Cory Spaulding and Leslie Yeisley request that the Siting Council reject Petition 1566 for failing to contain the minimum required information as required RSCA Section 16-50j-59 - Information Required.

RSCA Section 16-50j-59 - Information Required.

The required information listed in Section 16-50j-59 applies to petition 1566.

Exhibit 8

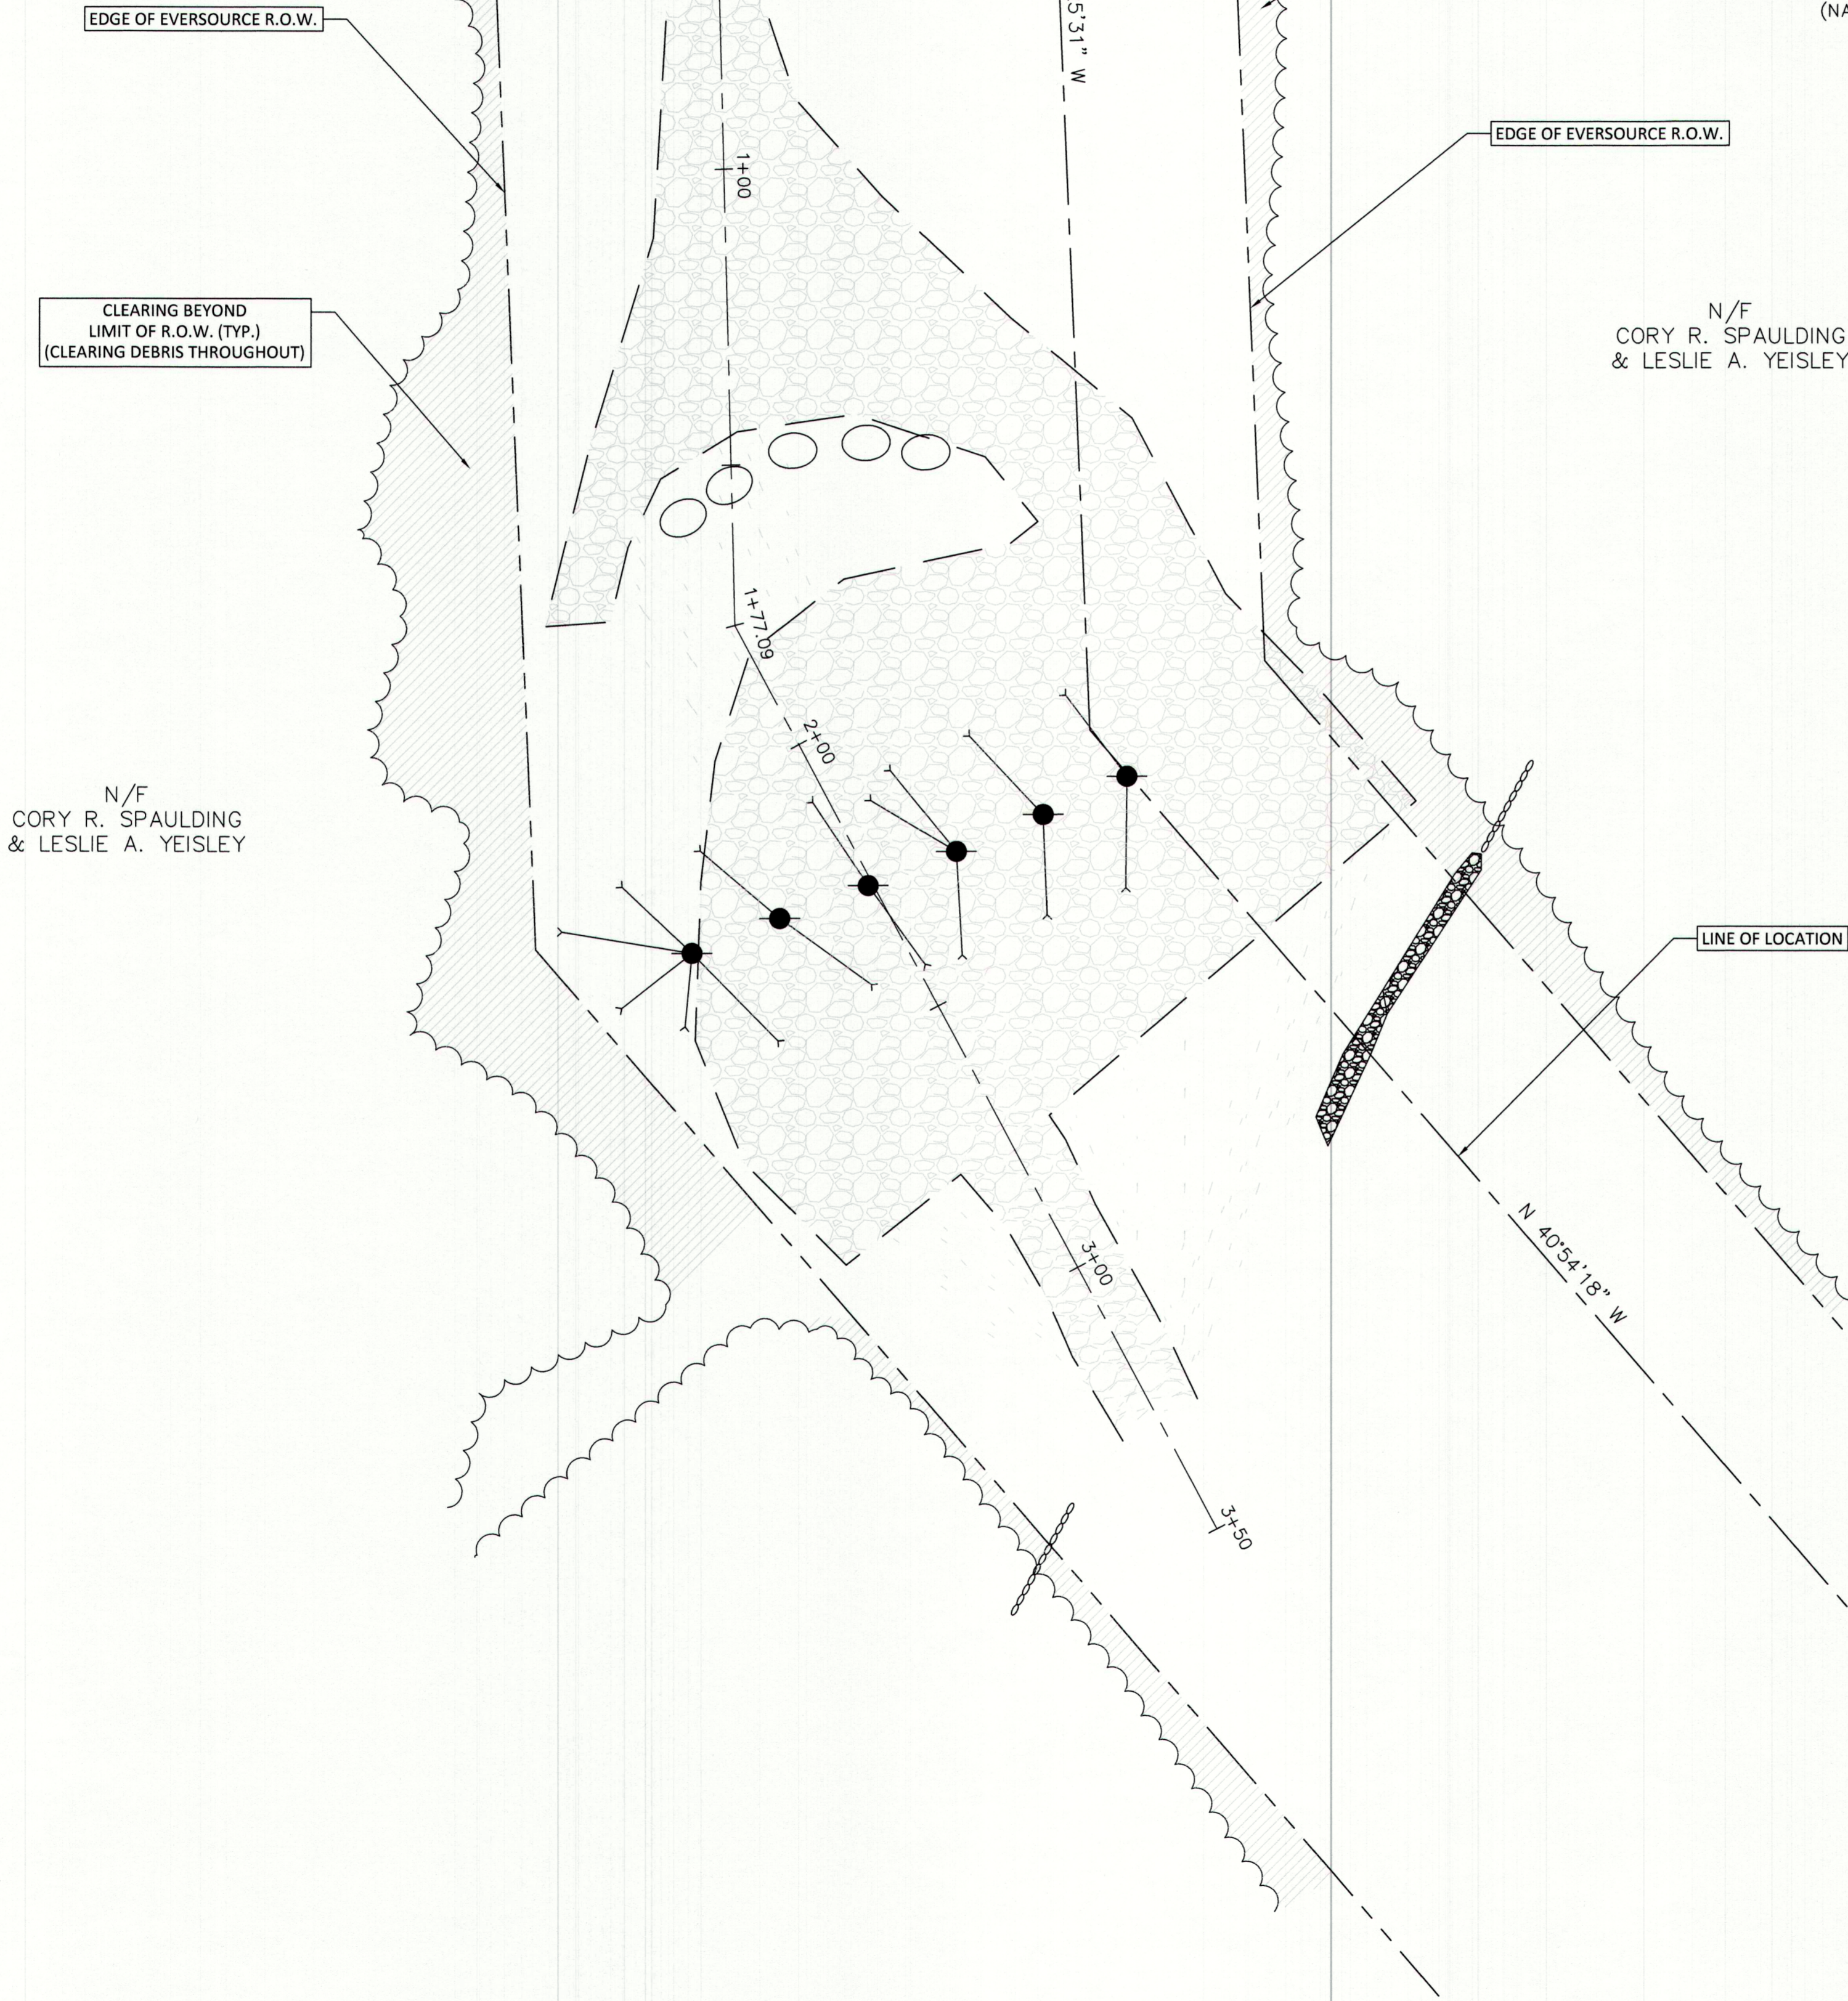
It is believed that the material was brought into site 7785 because it was a cheap and easy way to set new poles and the required guy wires, rather than drilling into solid rock ledge, which would have had minimal environmental impact and complied with the terms of the easement. In short, material was brought in, mounded up, the new poles and guy wires were stuck into the fill material rather than drilling into bedrock as was done when the poles were originally installed. Exhibit 8, entitled "Existing Clearing Limits", drawing 2 of 3 dated 4/15/22 (22-

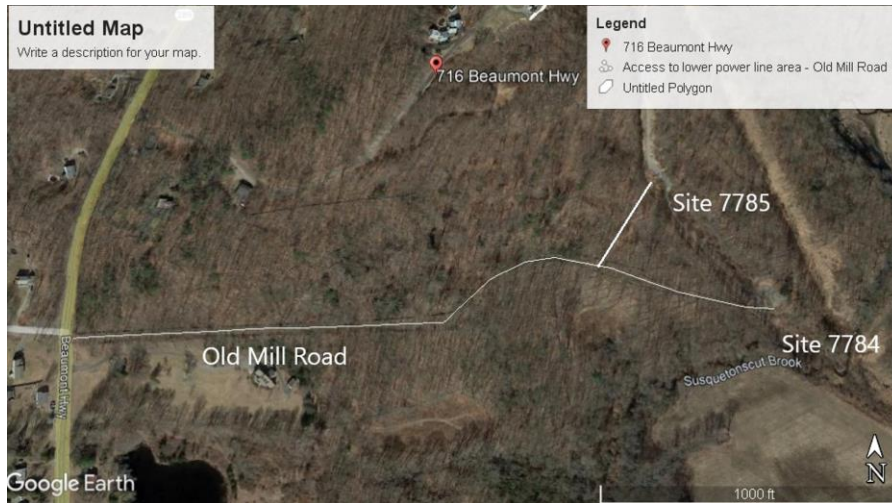
This image is from 2017 before the work began and depicts what existed between sites 7786 and 7785 pre-construction. Site 7786 is at the bottom of the photo and site 7785 is at the top of the photo. Notice there is no existing road where Eversource illegally constructed one. Where the line turns to the left, there is an existing road on the right that provides alternate access that Eversource chose not to use or to acquire rights to use. It is “The Old Mill Road”.

For sites 7784 and 7785, there was clearly a feasible and prudent alternative to building a road through this environmentally sensitive area. “The Old Mill Road” runs directly to both sites.

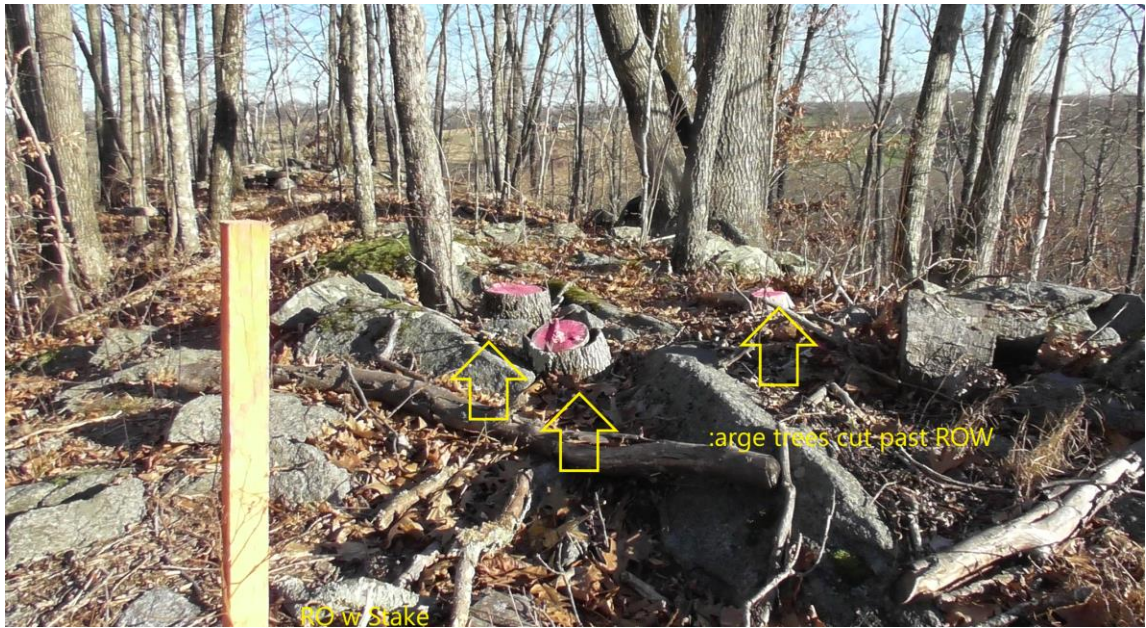
This image is from 7785 to 7786:
